<b>Dwelling type:</b>	House and Garage.
<b>Dwelling configuration:</b>	Single Storey.
<b>Nature of works:</b>	New Building.
<b>Stage of inspection:</b>	Final 2nd Re-inspection.
<b>Construction Type:</b>	Brick Veneer.
<b>Garage:</b>	Attached.
<b>Foundations:</b>	Slab.
<b>Builder:</b>

### **Defects, observations and other related comments from the Final Inspection on the 2021:**

**4.**

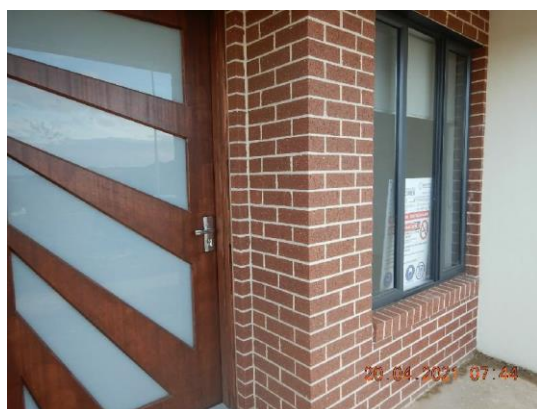
The internal corners documented have been constructed with unnecessary straight joins. The nominated bond for this dwelling is half bond and that is the method that should have been used throughout the brickwork, easily achieved by building in.

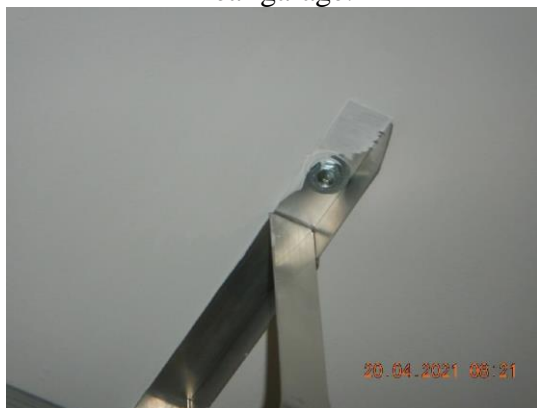
Replace removed door seal.

Damaged door seal.

Hammer damage garage rear door.

**14.**

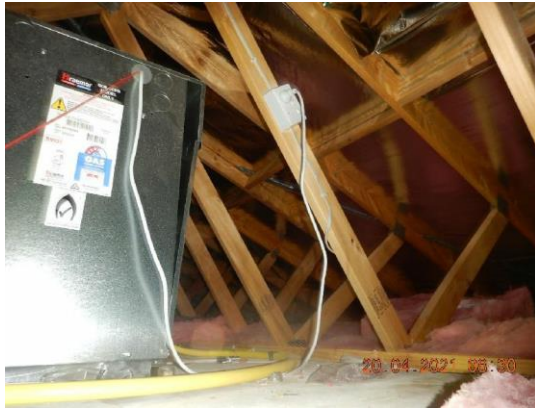
**AS 3000; 4.5.1.1:** - All lamp holders shall be located to be adequately protected against damage that might reasonably be expected. Lamp holders shall be installed not less than 1.8 m from the ground, floor, or platform, or be fitted with a suitable guard.

This requirement has not been met.

## 16.

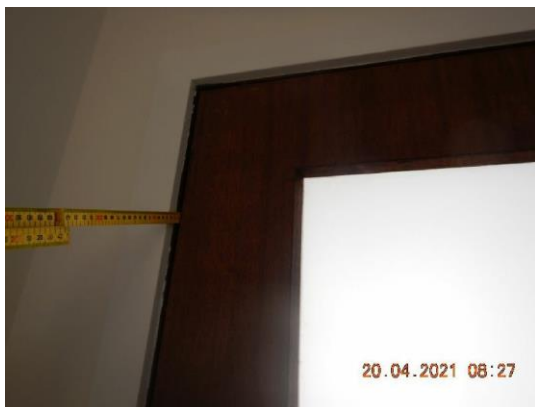
A few door margins will need to be reworked to comply with the inserted.

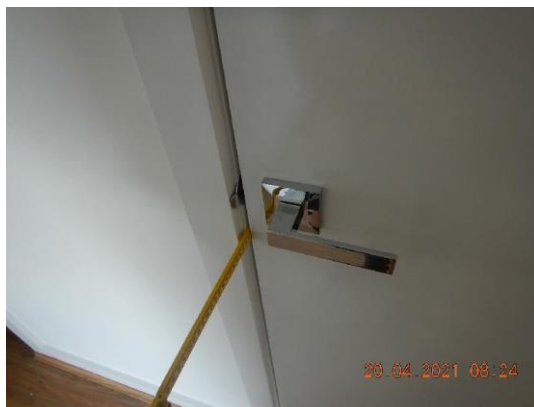
Check all.

#### 18.

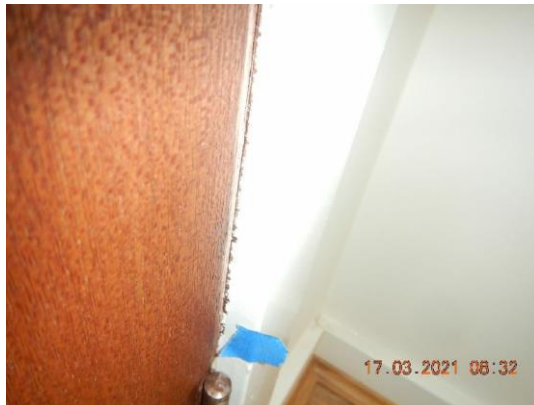
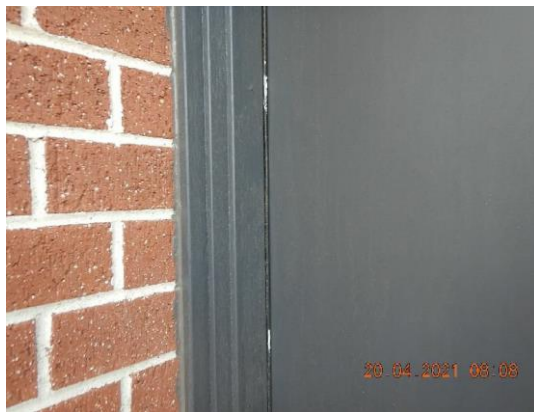
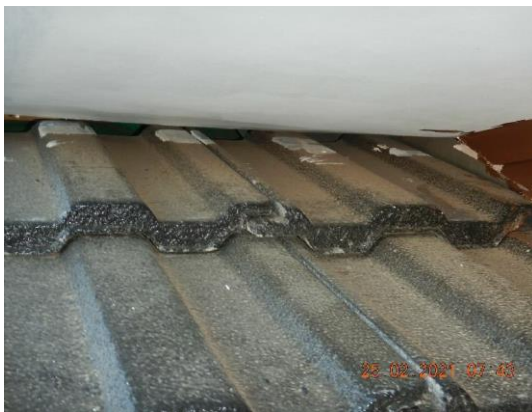
**AS 2311, C4 (a) (iv) & (b):** - Surrounding areas shall be clean, tidy, and undamaged. The painting to this dwelling has not met these requirements.

## 19.

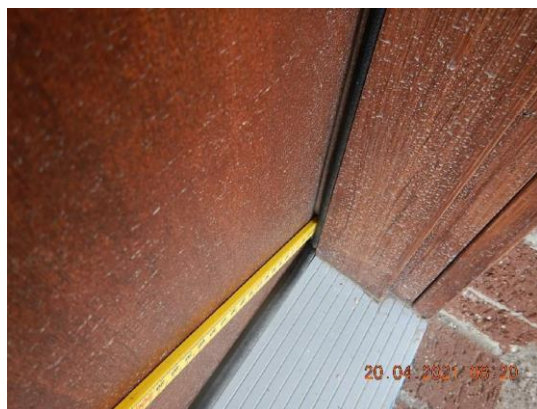
The required weather seal as documented is non-functional. The NCC and the energy report on the dwelling calls for all doors and windows to be sealed, all areas must comply.

## 21.

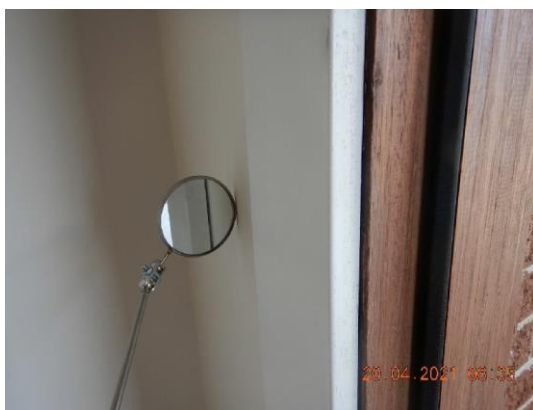
**NCC 3.12.3.5:** - Mandates that the dwelling is sealed. Perimeter window architraves and door architraves need to be gapped to the plaster as per the energy rating requirements and the NCC. All must be caulked closed to restrict the transfer of internal and external air.

All areas to comply.

26.

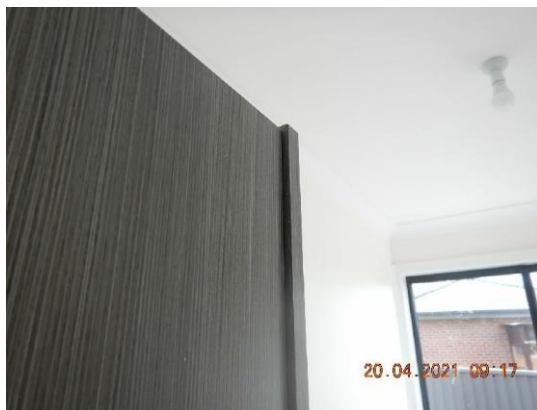
All cabinet door margins that need to be reworked to ensure that all are aligned. This includes the draw fronts.

All to comply.

30.

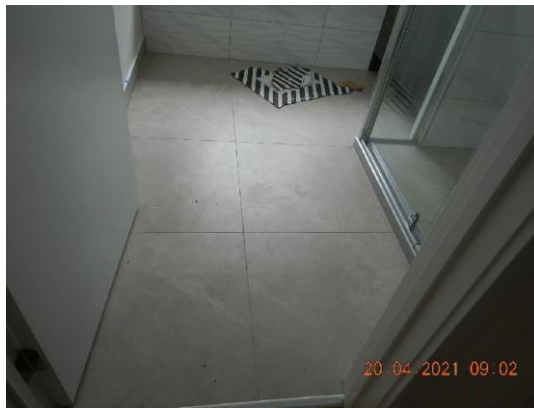
This requirement has not been met.

### 31.

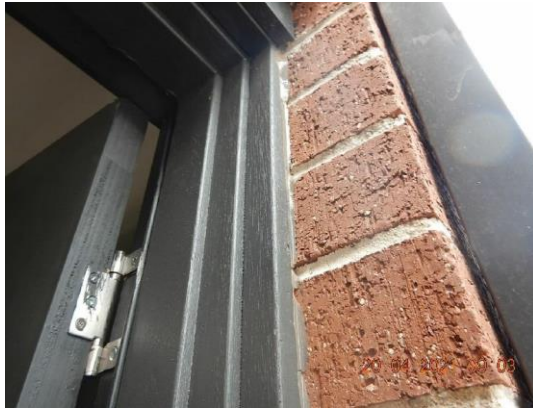
We noted poorly installed or missed caulking/gapping/grouting throughout the dwelling. The Builder will need to rework all areas prior to handover.

32.

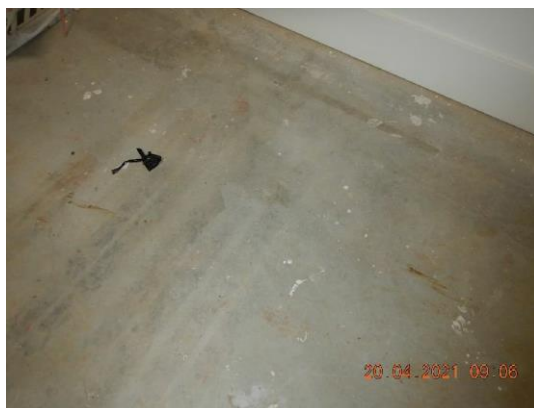
The concrete floors require cleaning to remove builder's waste including paint and plaster excesses etc.

This requirement has not been met.

33.

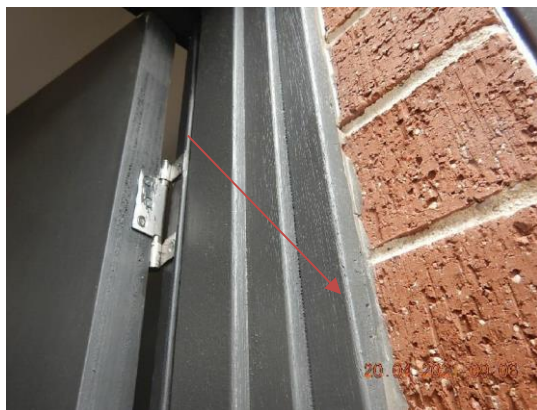
Door damage.
